**Addendum No. 1**

Contract No.: DA00309

WBS Element: 44226

*Stone and Elevated Walkway Construction in Dare County*

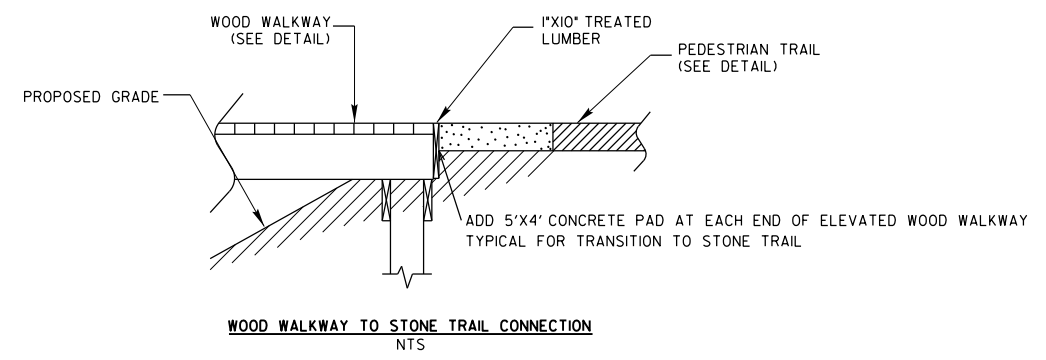
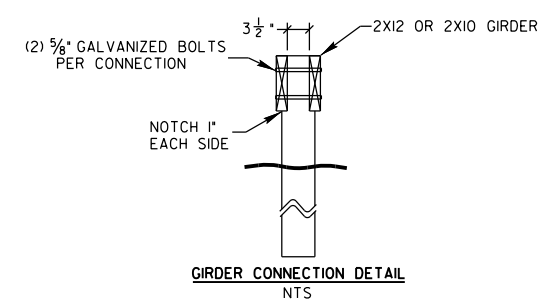
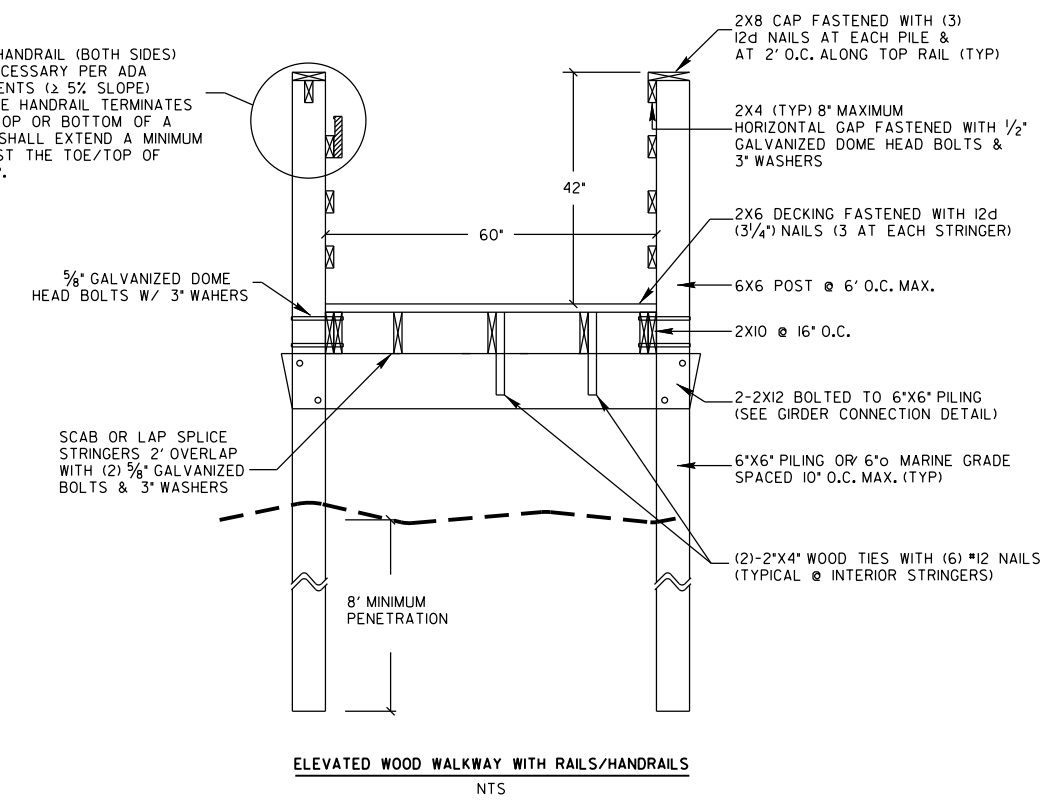
Plan Sheet No. 2 "Pedestrian Trail Section" has been revised to remove the reference to "78M Stone" and replaced it with "Granite Screenings". Please void existing Plan Sheet No. 2 and replace with revised Plan Sheet No. 2.

ALIGNMENT -LI-

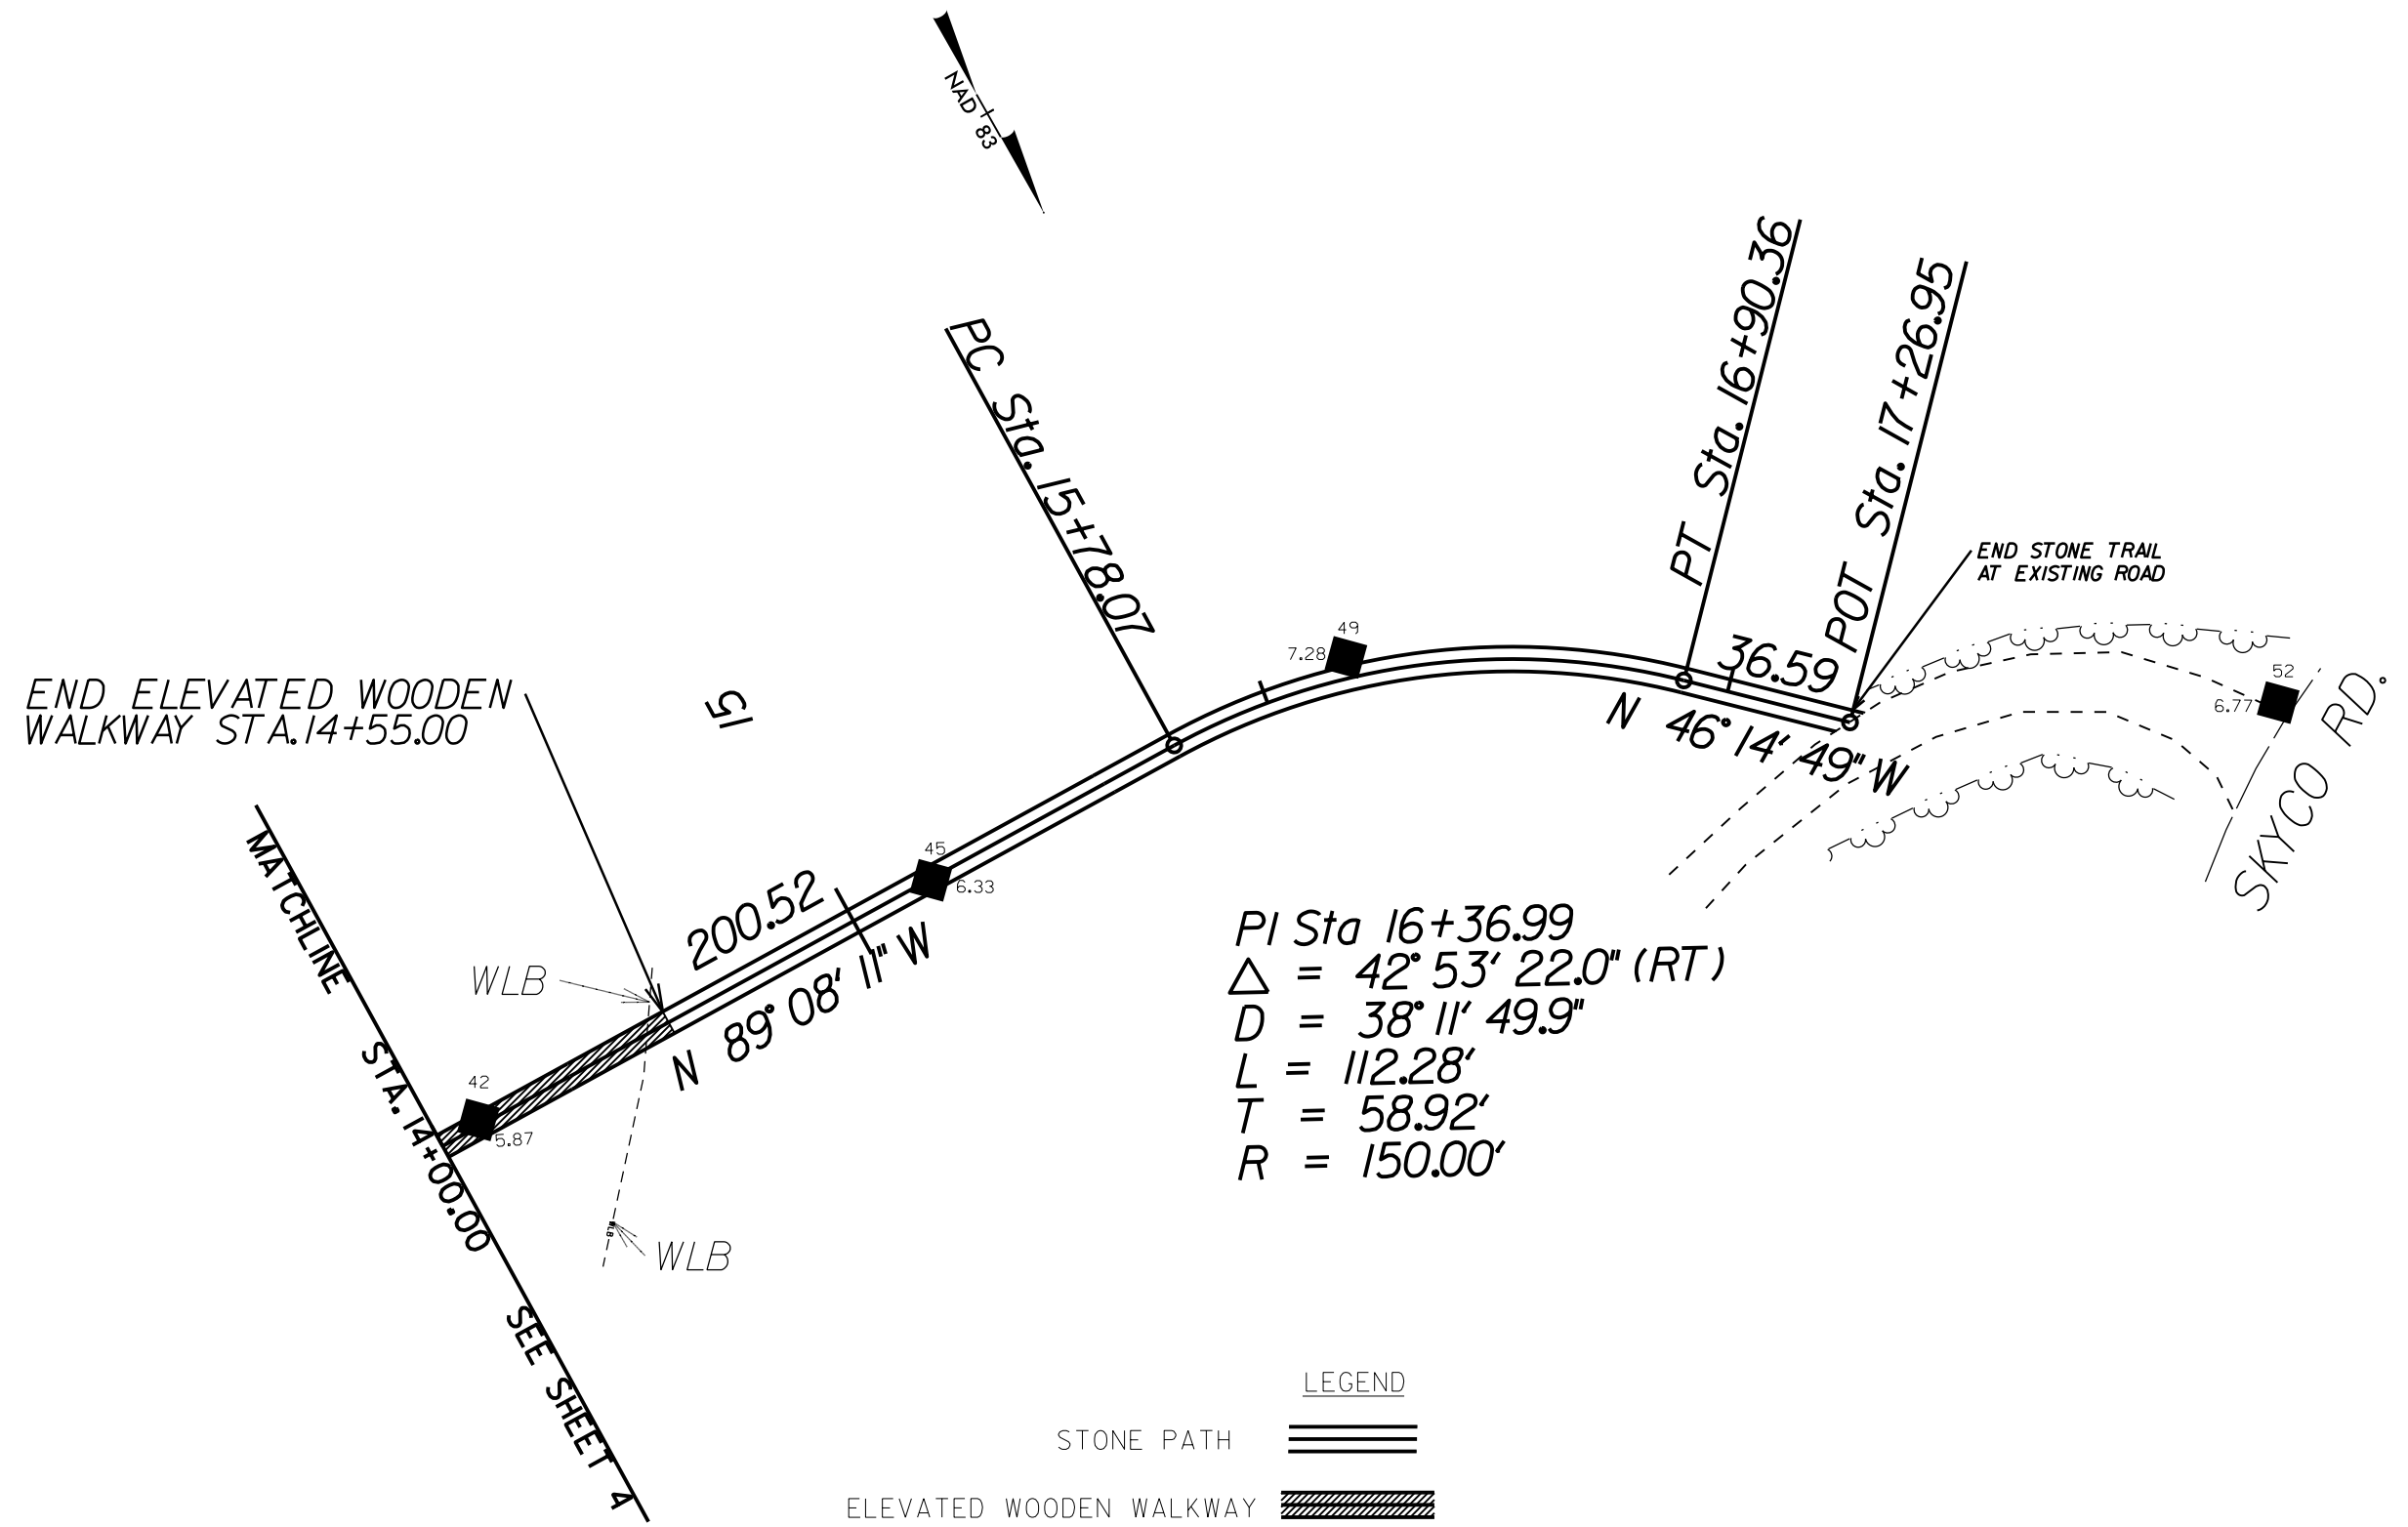
Plan Sheet No. 5 "Alignment - L1 -" has been revised to remove the Wheel Chair Ramp at Sta. 17+26.95. Please void existing Plan Sheet No. 5 and replace with revised Plan Sheet No. 5.

ALIGNMENT -L2-

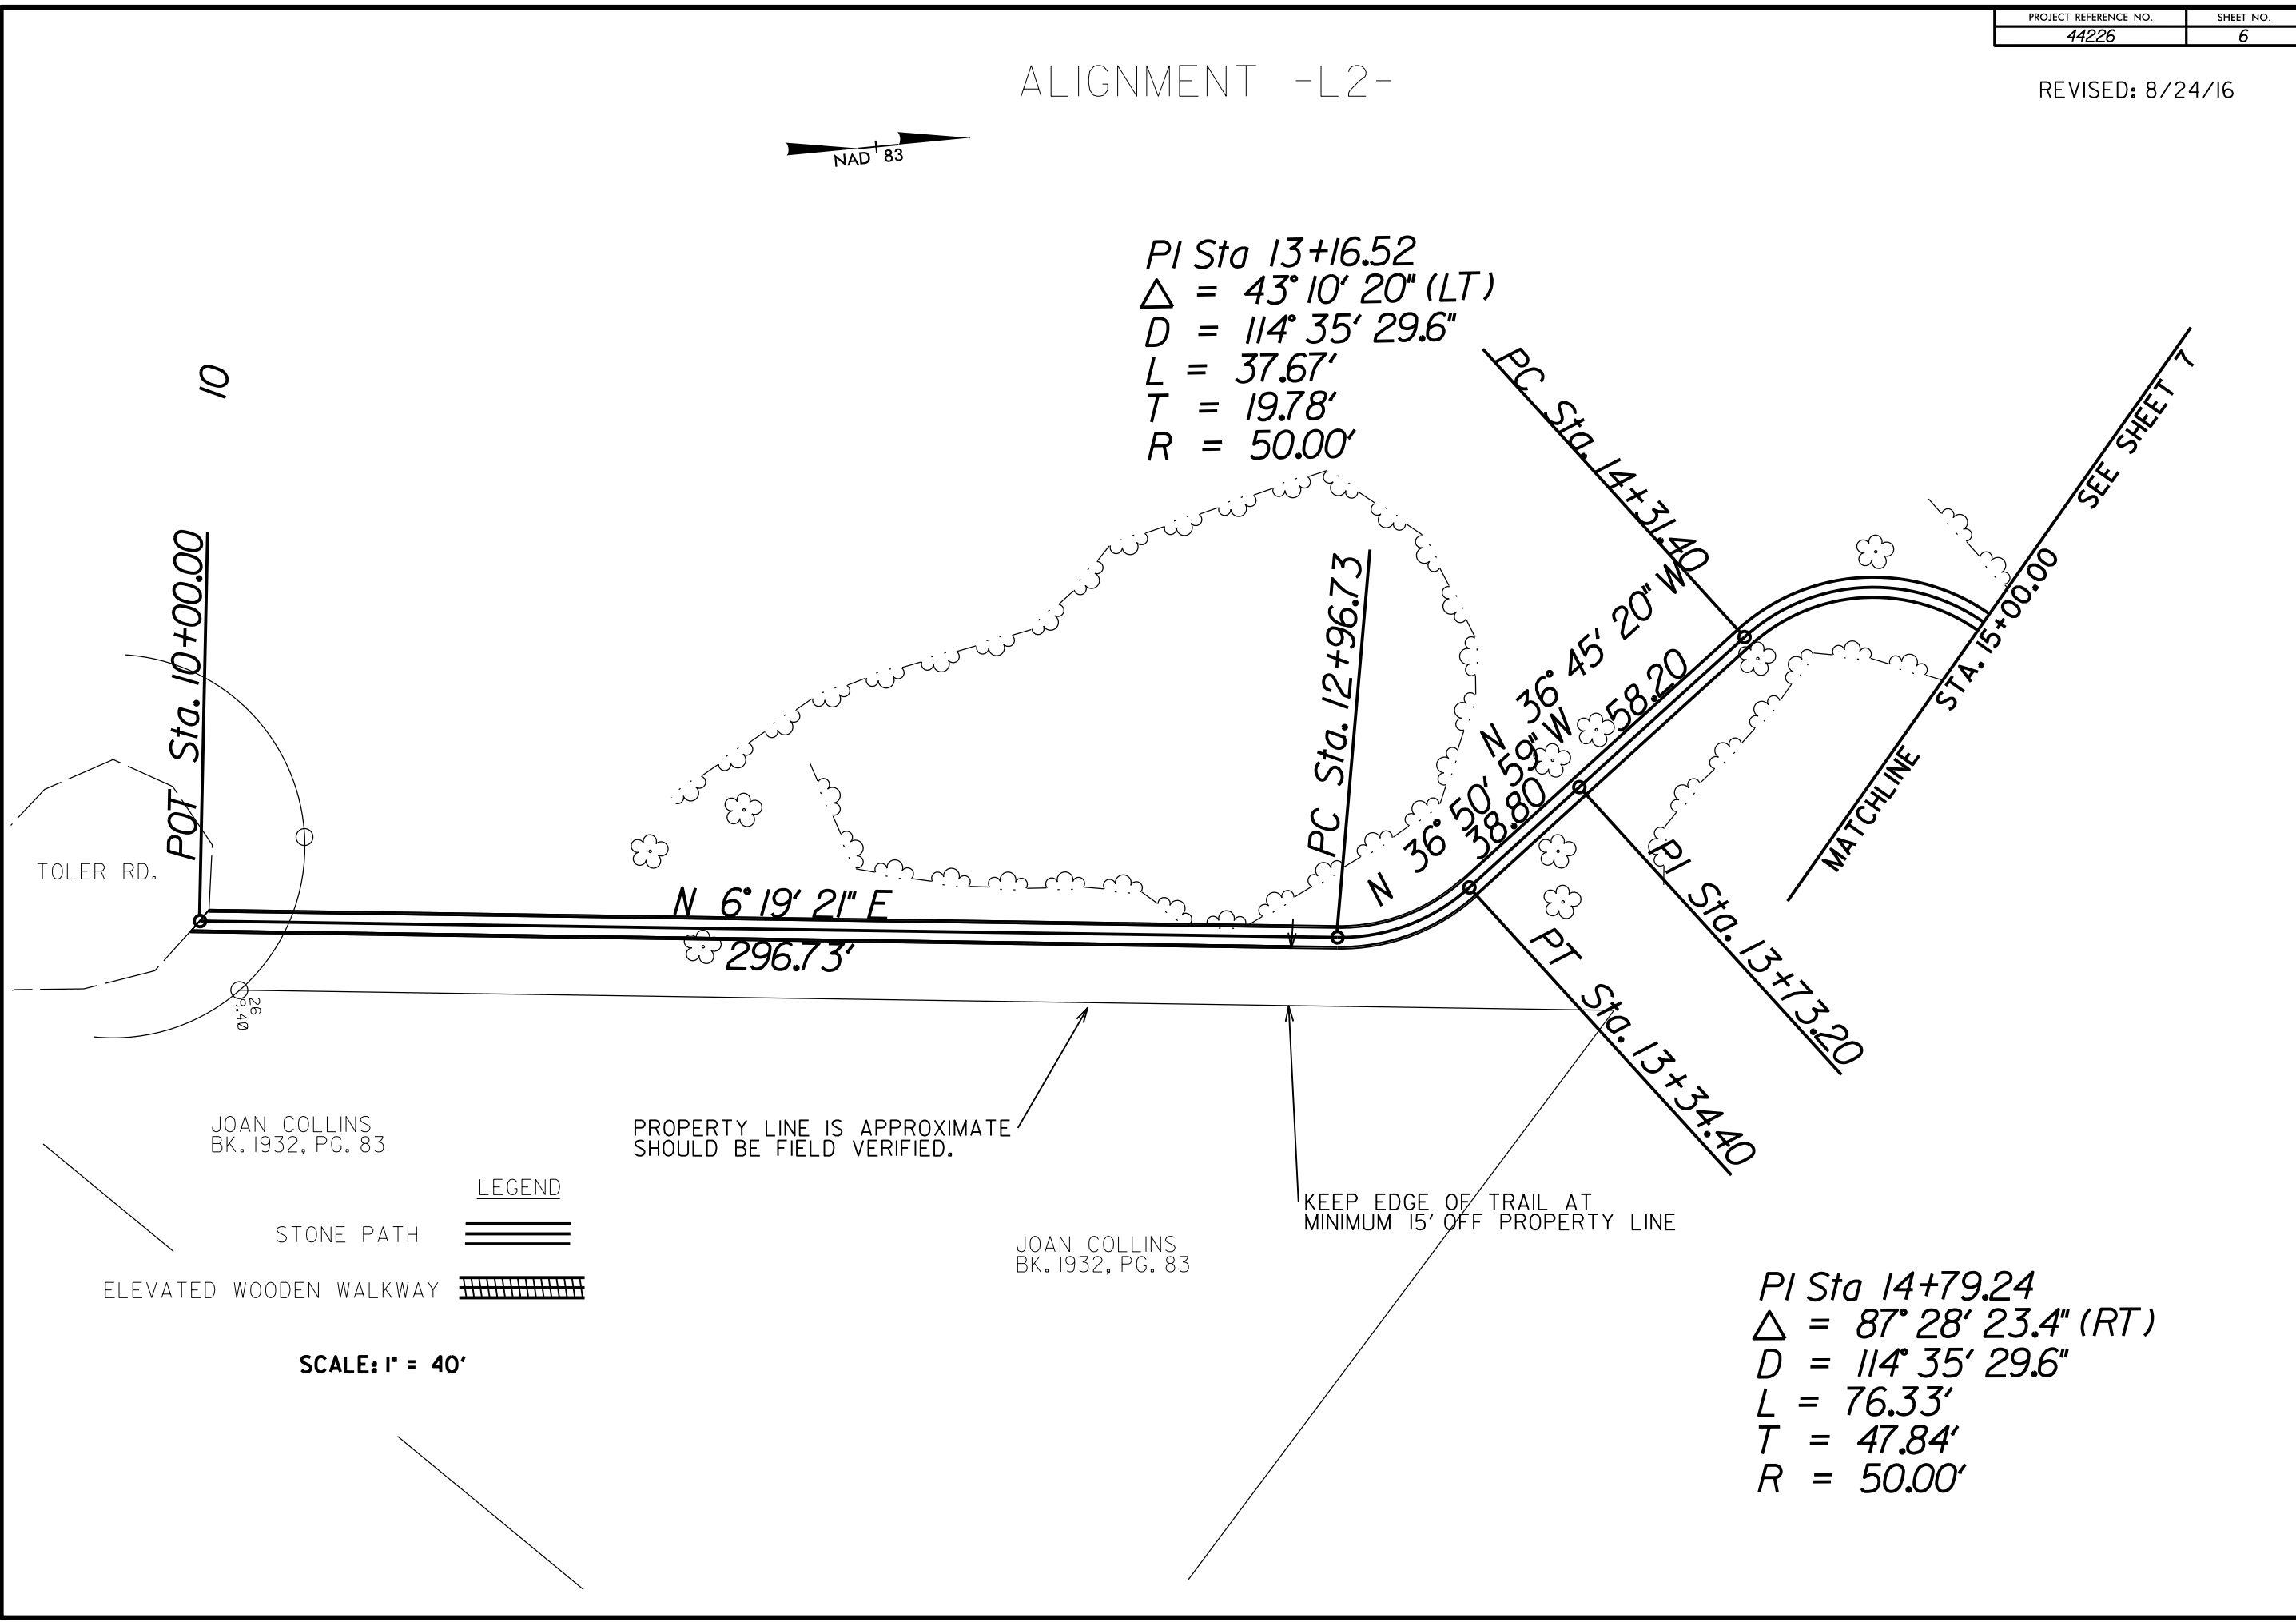
Plan Sheet No. 6 "Alignment - L2 -" has been revised to remove the Wheel Chair Ramp at Sta. 10+00.00. Please void existing Plan Sheet No. 6 and replace with revised Plan Sheet No. 6.
